National Aeronautics and Space Administration

Reply to Attnot JSC, GA-92-105

SUBJECT: Shuttle/MIR Cargo Configuration

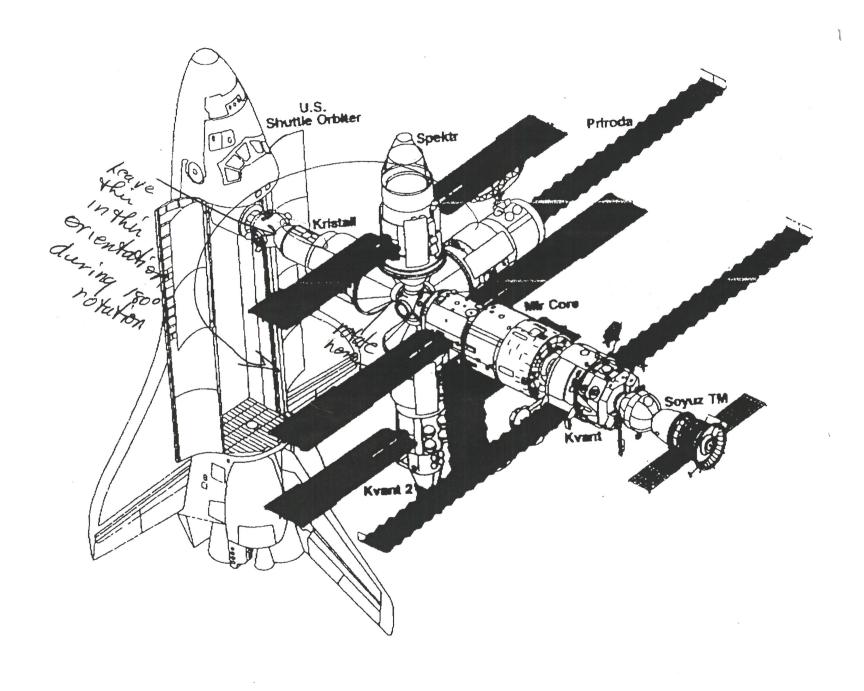
The Shuttle/MIR team has continuously been assessing the flight performance for the Shuttle/MIR mission (STS-70). When the team presented its preliminary findings to you and others on September 15, 1992, the cargo configuration included a short spacelab module to conduct mission science because performance margins at that time required the lighter weight module. As a result of the continuing performance assessments, we have now concluded that the long spacelab module is viable and is the preferred configuration because of its larger volume to accommodate payloads/experiments and Russian logistics, and to minimize the impacts on KSC/MSFC.

The two main reasons leading to a change in the performance story are:

- 1. More accurate hardware and vehicle weights and a decrease in the flight performance reserve results in approximately 650 pounds of additional capability.
- 2. For the science equipment being flown, the short module was volume limited, not weight limited, and this required that equipment be relocated forward in the airlock and middeck, resulting in the addition of aft ballast. With the long module, all of the equipment can be accommodated in the module and the weight increase of the long module is offset by deleting the aft ballast. The long module configuration can satisfy all of our payload/experiment requirements and provide some margin.

Therefore, we are baselining the long module configuration with the *#* appropriate cargo element control weights and are initiating the engineering activities required for implementation.
